**DOCUMENT 00 90 00
ADDENDUM**

ADDENDUM: 3

PROJECT: WESTERN TECHNICAL COLLEGE
SPARTA PUBLIC SAFETY TRAINING SIM CITY
11177 COUNTY HWY 1
SPARTA, WISCONSIN 54656
PROJECT NO. 25039

Consultant:

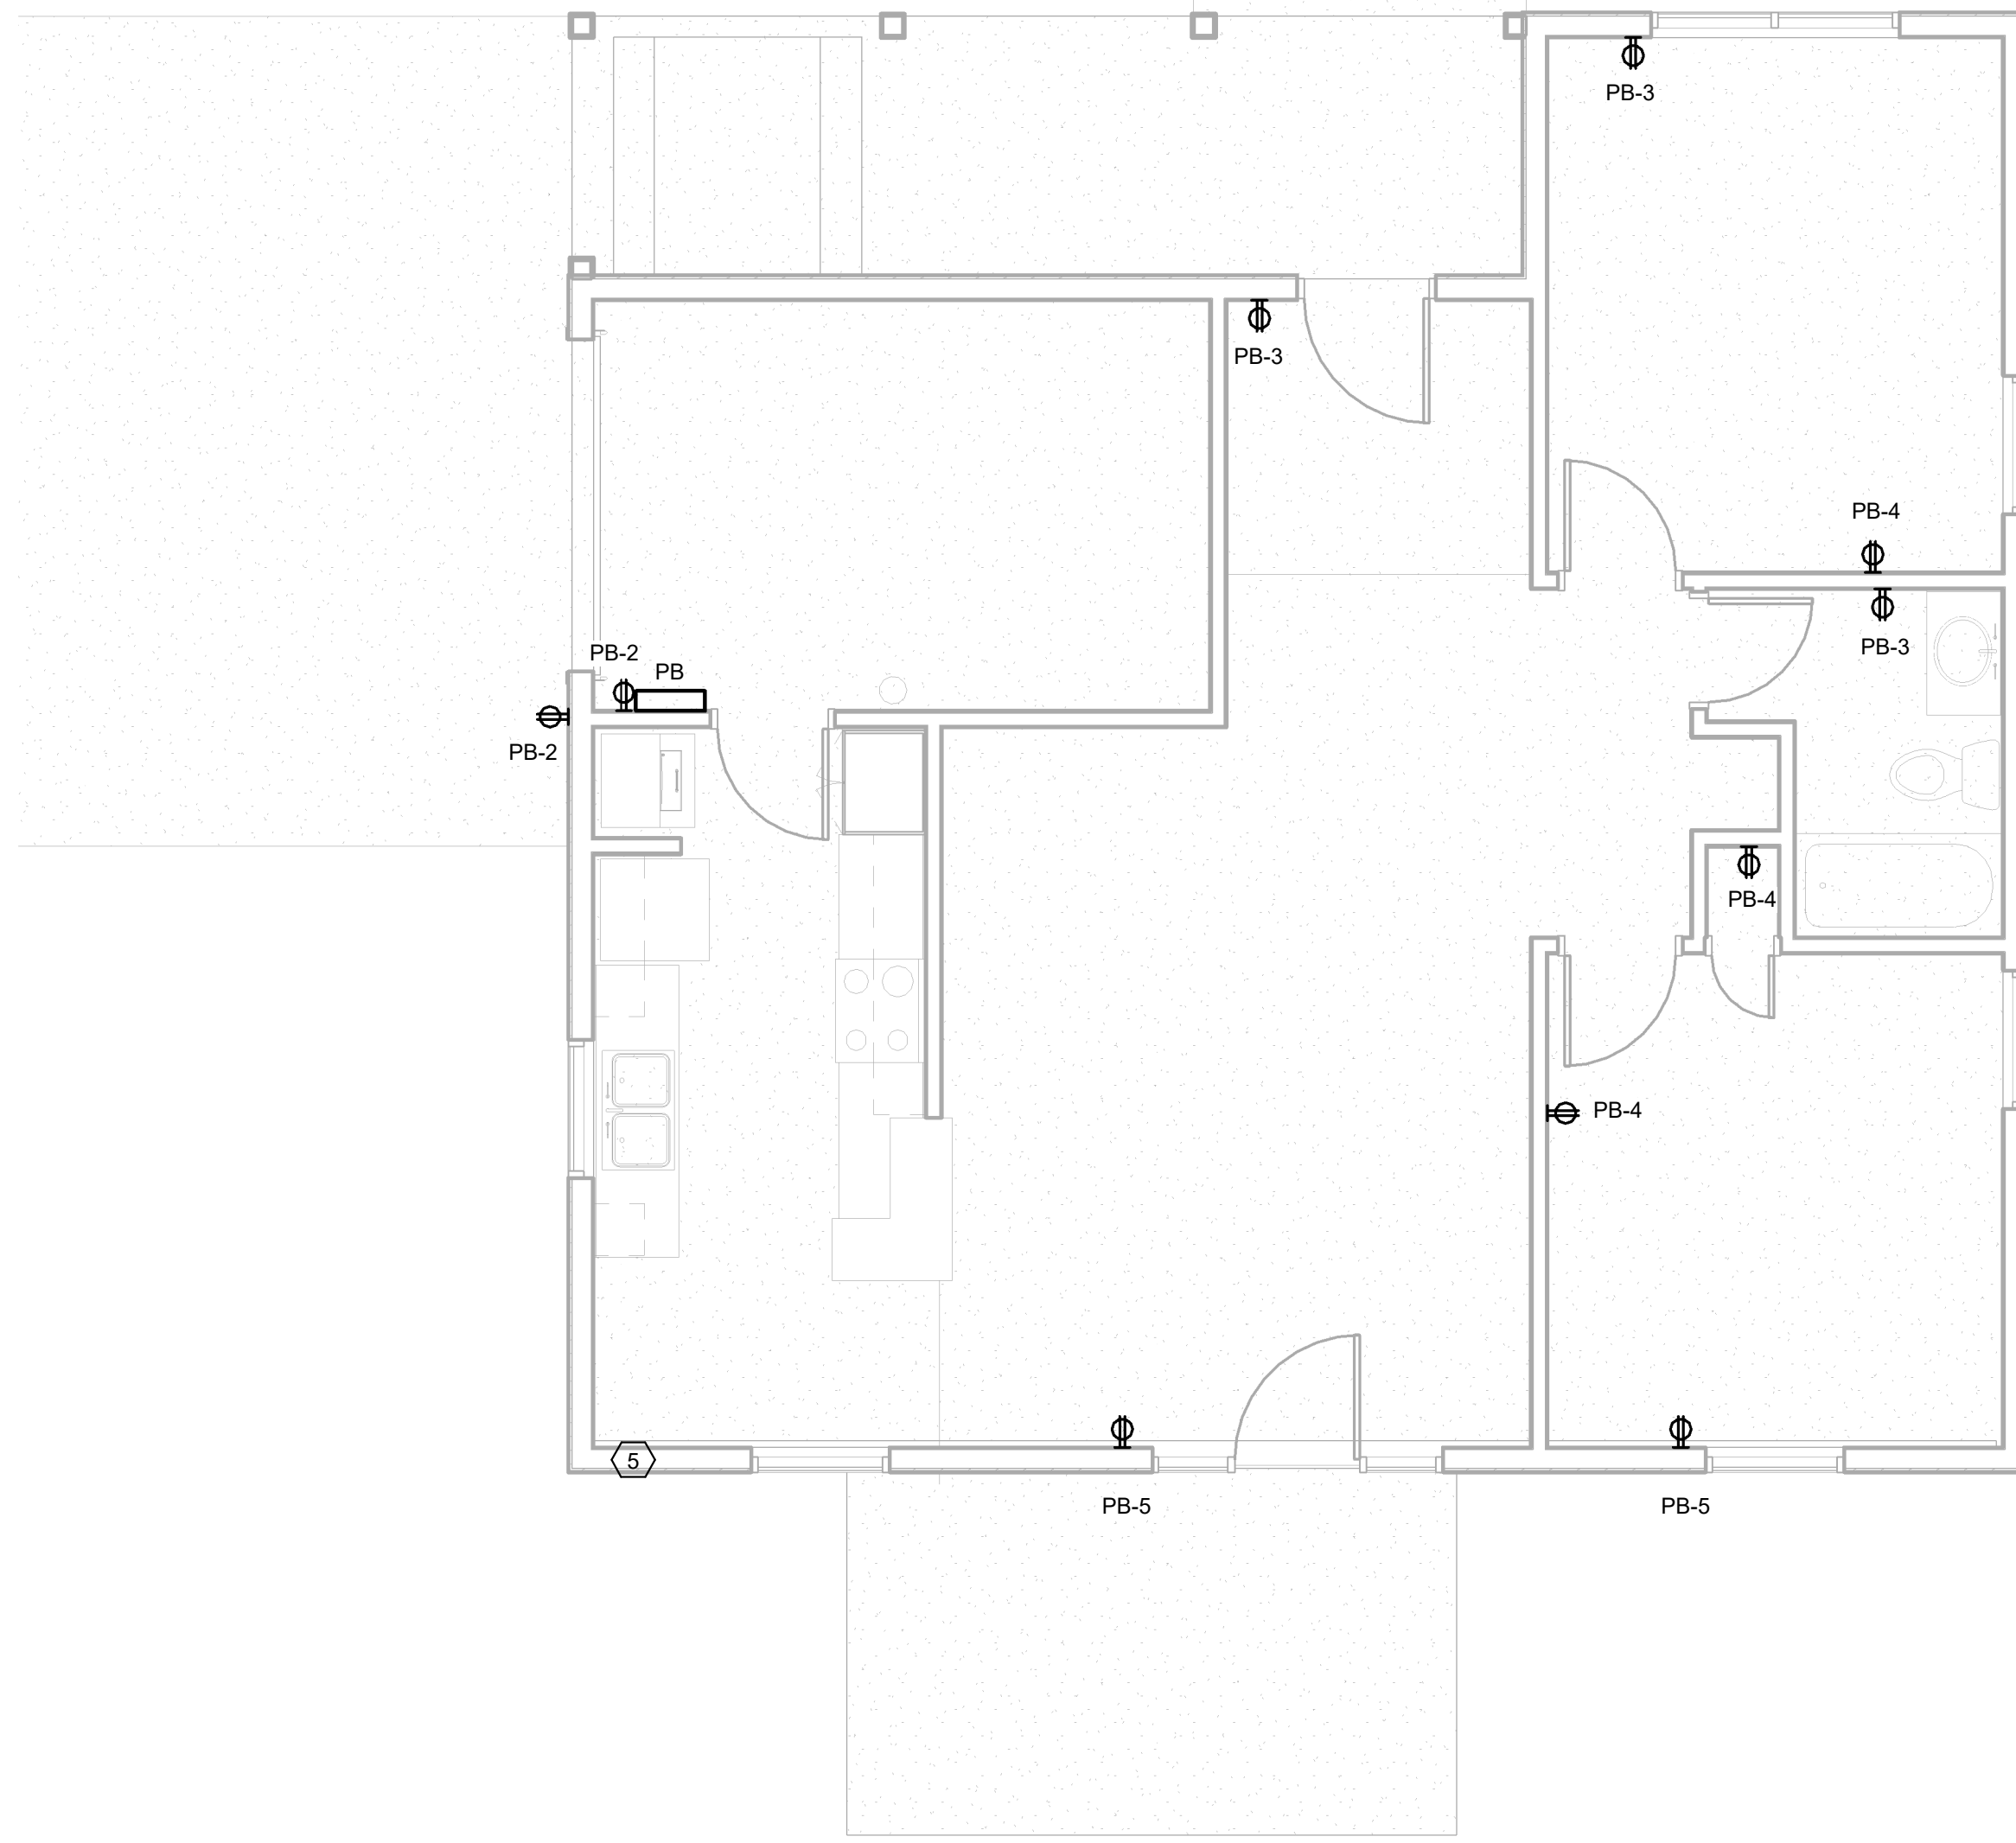
3. Sheet E001 SITE PLAN 21"x30"
 - a. See the revised sheet included in this addendum. Disregard the previous version.
 - b. Revised pole detail, site plan layout, and keynote. See clouded changes.

E200

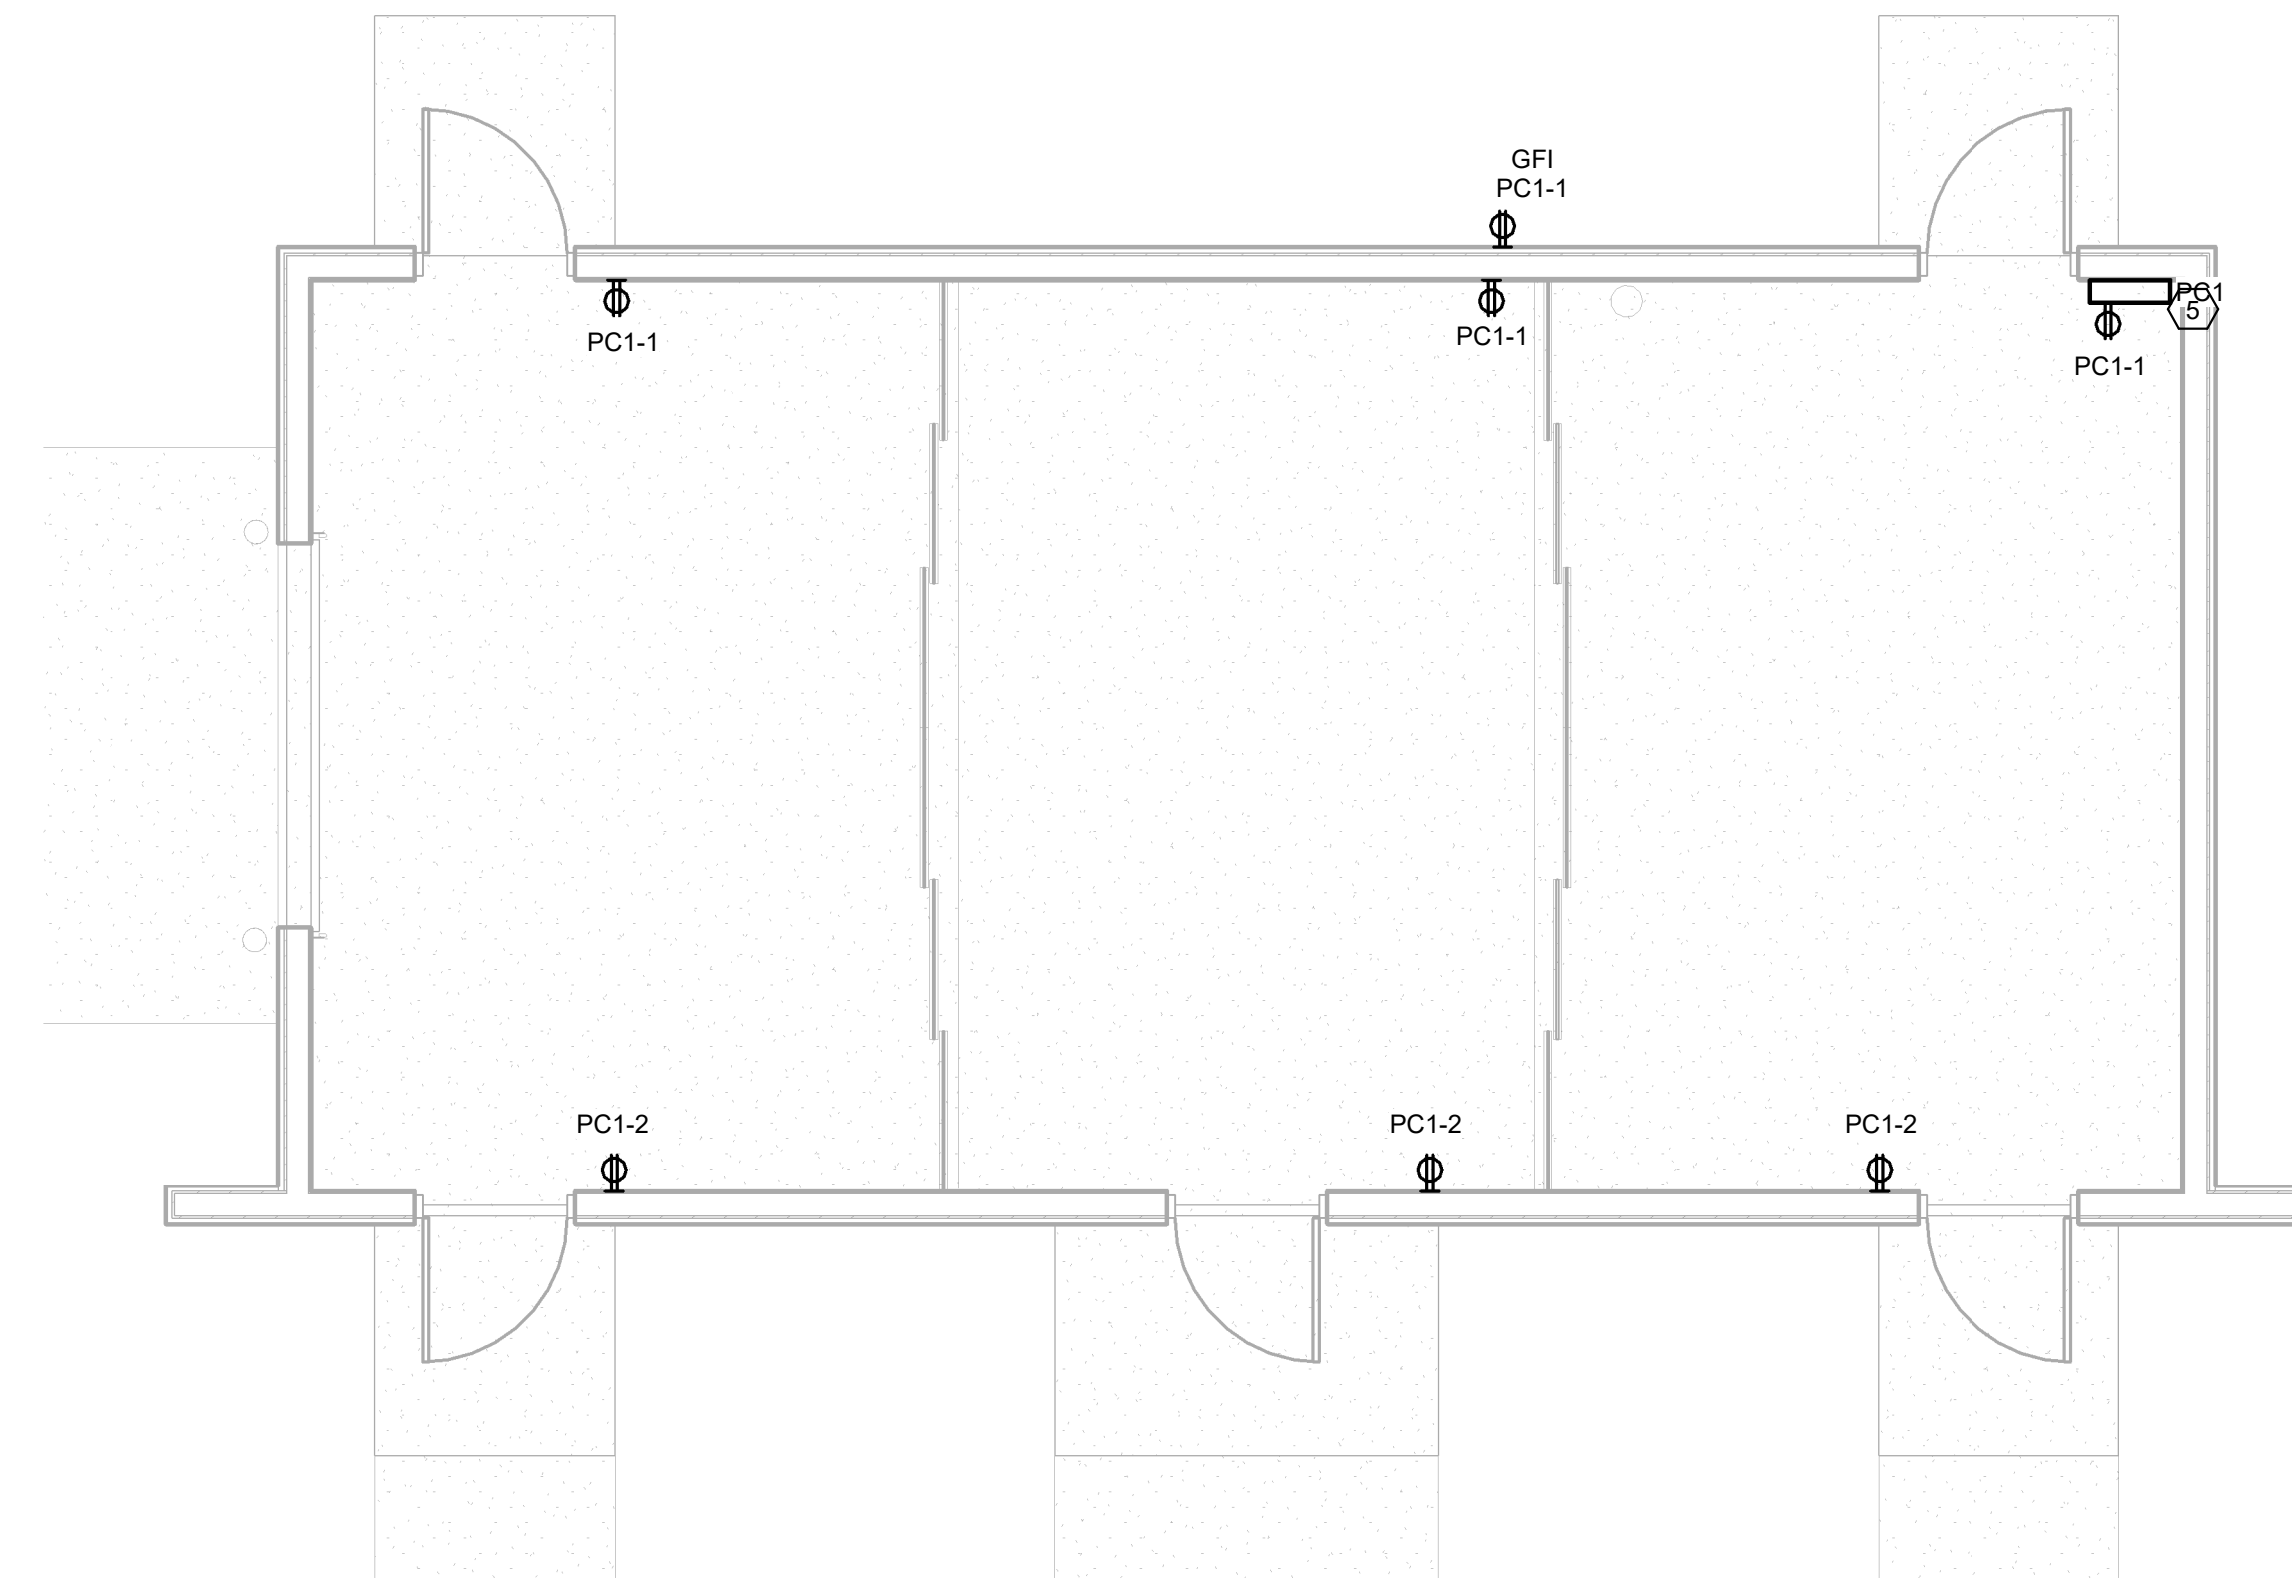
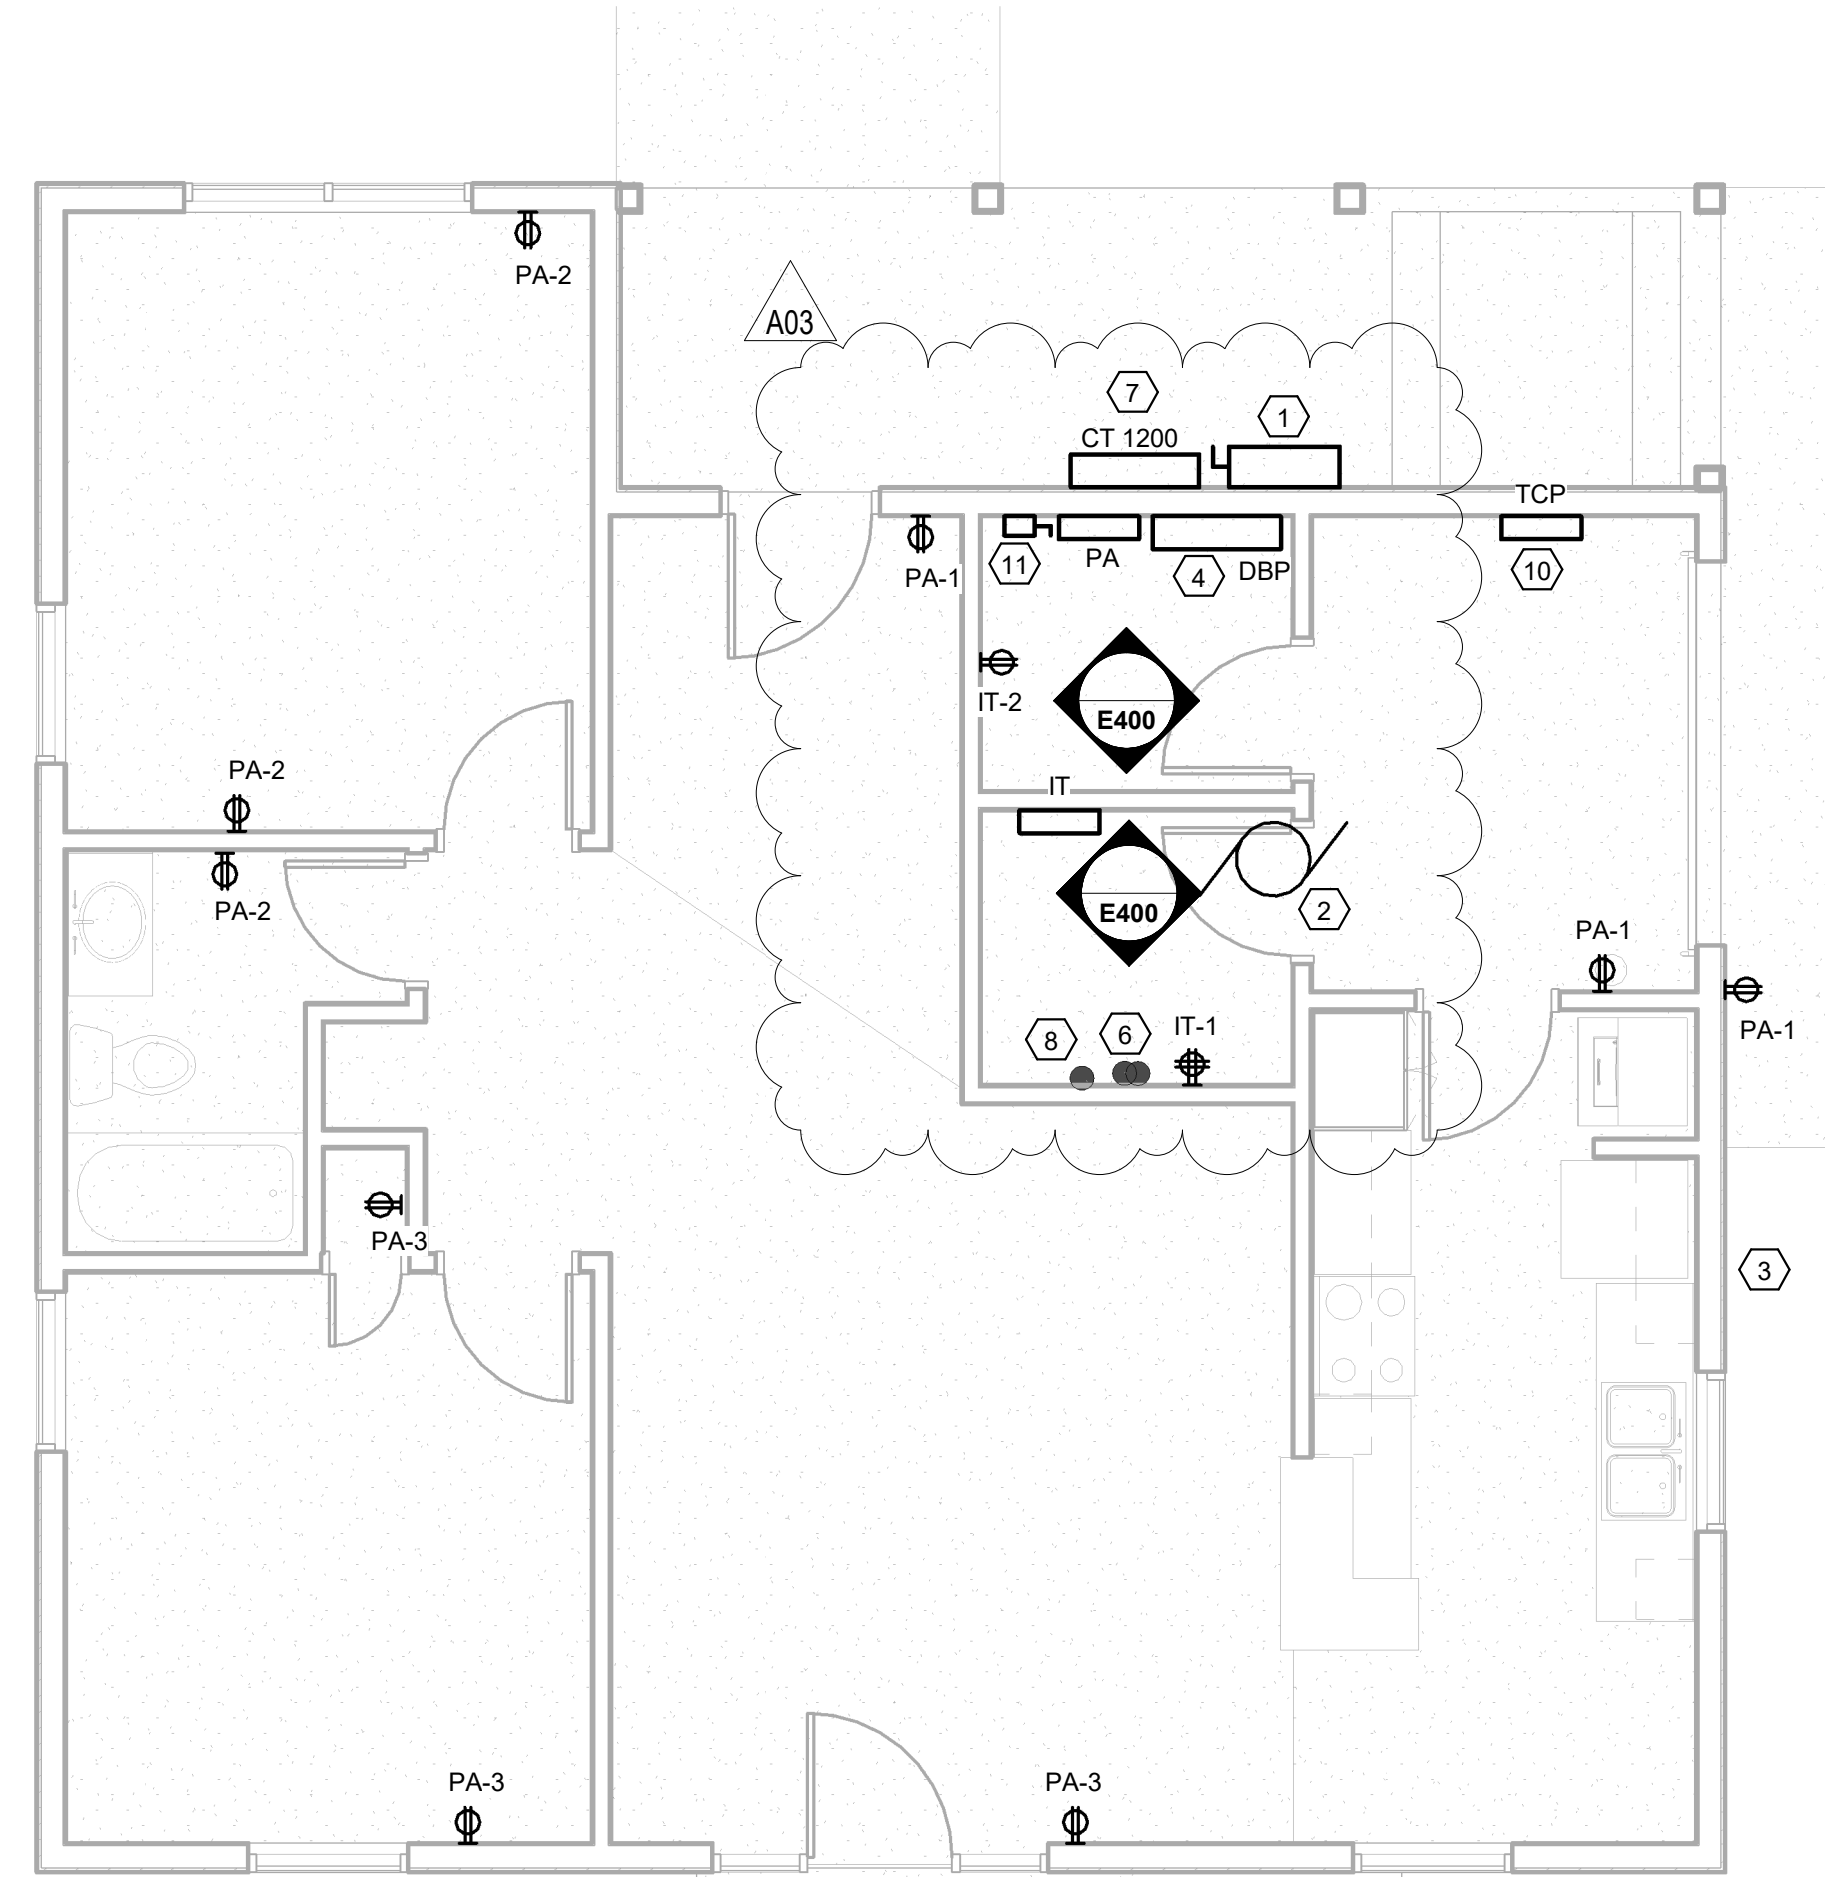
4. Sheet E200 POWER PLAN 21"x30"
 - a. See the revised sheet included in this addendum. Disregard the previous version.
 - b. Revised panel locations and modified keynotes. See clouded changes.
